**TO:** Chairwoman Laura Semanson, Forsyth County  
**ATTN TO:** Leslie Silas, Planning Manager, Forsyth County  
**FROM:** Mike Alexander, Director, ARC Center for Livable Communities  
**RE:** Development of Regional Impact (DRI) Review

**Name of Proposal:** Empire Highway 306 DRI 3594

**Description:** A DRI review of a proposal to construct a mixed-use project with 60 single family lots, 69 townhomes, 303 multi-family apartments, 13,000 SF of office space, 10,000 SF of retail, and 20,000 SF of restaurant space on a 68 acre site in Forsyth County. The site has been partially developed for agricultural use. Baldrige Creek runs through the site.

The project should adequately address the impacts of the proposed development on stormwater runoff and downstream water quality.

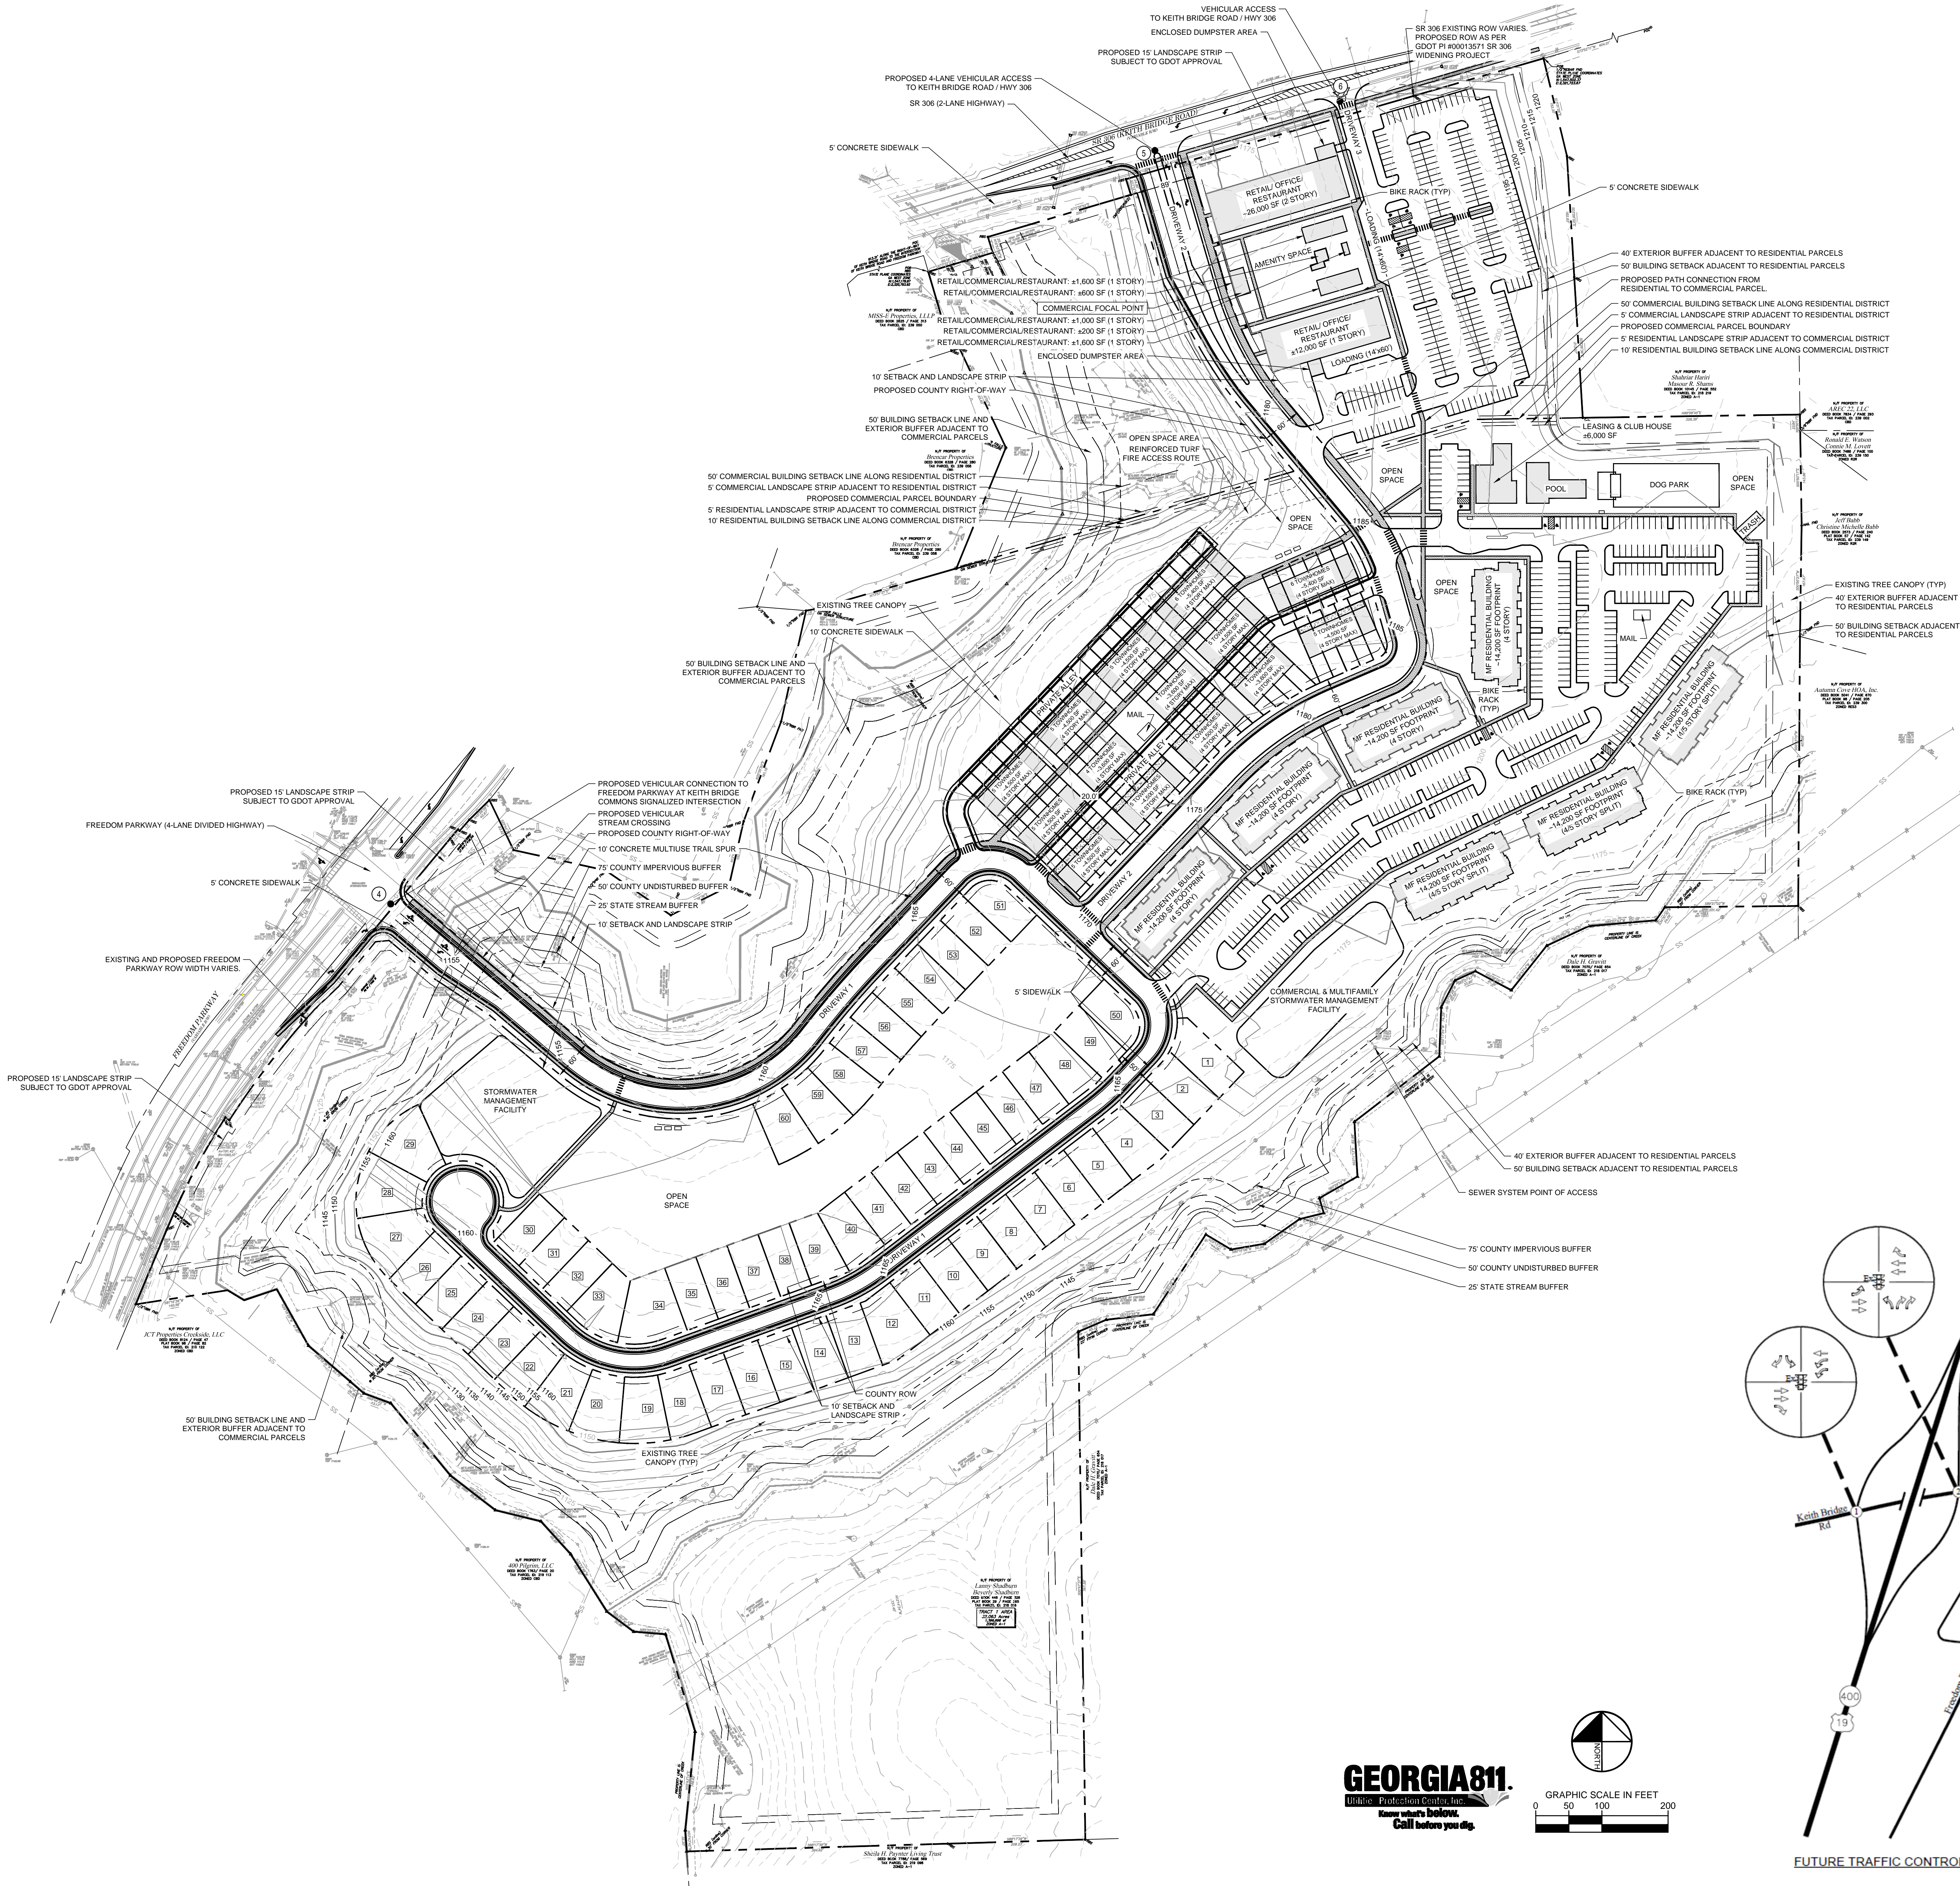
A total of 1,126 parking spaces are provided which is almost double the required number of 677 spaces; no EV charging stations appear to be proposed. A reduction of total spaces to an amount closer to the minimum required and the provision of EV parking spaces would be supportive of regional transportation policies.

Both the USGS coverage for the project area and the submitted site plan show two streams on the project property. Baldrige Creek runs along the northwestern, western and southwestern sides of the property and a tributary to Baldrige runs along the eastern side of the project property, joining Baldrige Creek near the southern end of the property. The site plan shows the 25-foot State Sediment and Erosion Control buffer as well as the Forsyth County's Stream Buffer Ordinance's 50-foot stream buffer and 75-foot impervious setback along both streams. The only proposed intrusions on the site plans are a stream crossing accessing

the property from Freedom Parkway, which is exempt from the buffer standards and the possible intrusion of a proposed 10-foot wide multi-use trail along Driveway 1 a few feet into the 75-foot setback, which may require a variance from the County.

Much of the existing site is wooded; additional retention of existing trees on the site would be desirable and in keeping with regional goals regarding carbon sequestration and climate change/heat island effect mitigation.

Incorporation of green stormwater and heat island mitigation designs for the roughly 1,126 surface car parking spaces proposed would be supportive of regional environmental policies.

Approximately 36 acres of the site are shown as open space and water quality protection buffer areas. Designation of this area as managed open/conservation space would substantially reduce the overall impact of the project. There may be potential opportunities for linking these fragmented undeveloped areas with adjacent undeveloped or protected areas to ensure their maintenance and potential use for recreation or habitat preservation.
